**Subject: MHI's Response to US-APWR DCD RAI No. 960-6709 (SRP 03.07.02)**

Response to Request for Additional Information No. 960-6709

**RAI NO.:** NO. 960-6709  
**SRP SECTION:** 03.07.02 – Seismic System Analysis  
**APPLICATION SECTION:** 3.8.4, 3.8.5  
**DATE OF RAI ISSUE:** 09/24/2012

US-APWR STANDARD PLANT STRUCTURES - PLAN VIEW

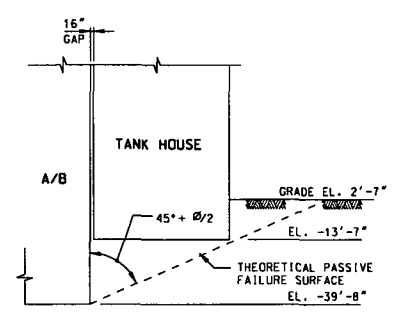
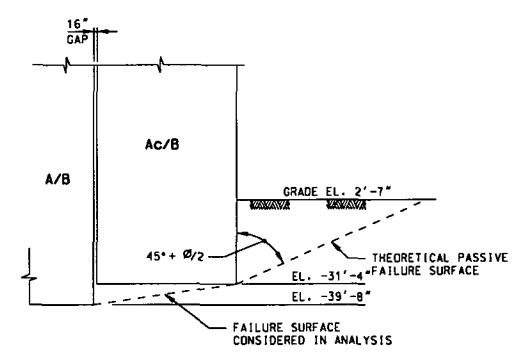
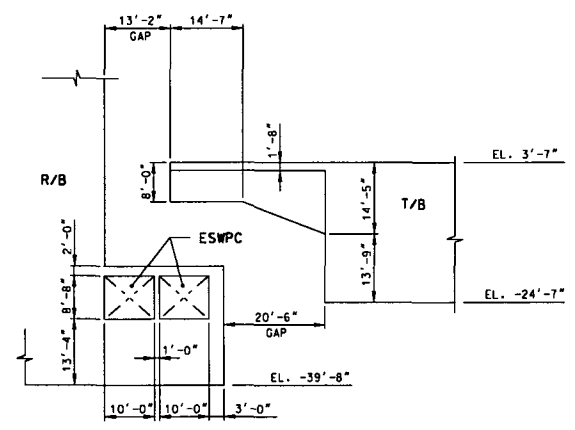
- a) In order to judge the adequacy of the gaps, to document which structures are adjacent to each other, and to document the structures that share a common basemat, the applicant is requested to provide a figure that shows those information. The figure should include all of the Seismic Category I structures and non-Seismic Category I structures at the plant site, the boundary of the separate concrete basemats, and the magnitude of the gaps between adjacent basemats (below grade and above). The structures should include those within the MHI USAPWR design certification and those that are within the COL application scope.

- b) Explain how the adequacy of gaps between the adjacent structures will be determined in view of the magnitude of sliding that may occur.
  - c) Describe how the seismic building response is combined with the potential sliding displacement, and how the total response of the two adjacent structures is compared (assuming out of phase motion) to ensure sufficient gaps exist with some factor of safety.

- a) A figure including a plan view and vertical sections for the Standard Plant structures is provided following this set of responses. This figure will be included in Section 5.5 of the TR. The exact locations of the structures within the COL applicant's scope are site specific. Therefore these structures could not be included in the figure. Adequacy of the gaps between the site specific structures and the Standard Plant structures will be addressed by the COL applicant.
- b) The adequacy of the gaps between adjacent structures will be addressed, in view of the potential sliding magnitude, as follows:

1. The Access Building and the Tank House weigh approximately 28,000 kips and 16,000 kips, respectively. The Reactor Building complex weighs about 1,200,000 kips. Therefore, the Access Building and Tank House weigh about 2.3% and 1.3% of the Reactor Building complex, respectively. Thus, any sliding of the Reactor Building (R/B) Complex toward the Access Building and/or the Tank House will result in pushing these structures in the sliding direction of the R/B Complex, with compression of the material in the gaps and subsequent reduction of the gap size. This gap size reduction is calculated as described in the answer to Question 212(c), amplified by a factor of safety of 2, added to other gap closures due to structure tilt and flexure and calculated in Technical Report MUAP-10006, and verified against the initial gap opening shown in Attachment 1. The maximum expected increase in pressure in the gap induced by sliding is considered in the design of adjacent basement walls.

2. The gap between the R/B Complex and the Turbine Building (T/B) is much larger (see Attachment 1), so there is no danger of contact between structures due to gap closure. A potential issue is the increase in pressure in the backfill in the gap due to the two structures (R/B Complex and T/B) sliding toward each other. The nonlinear sliding analysis will provide relative displacements of the R/B Complex and the T/B and resulting gap closure that will be used to calculate the increase in pressure on the structural walls adjacent to the gap, due to compression of the backfill in the gap. These pressures will be used for the design of structural walls.

c) Gap closure due to seismic building response including potential sliding is calculated as follows:
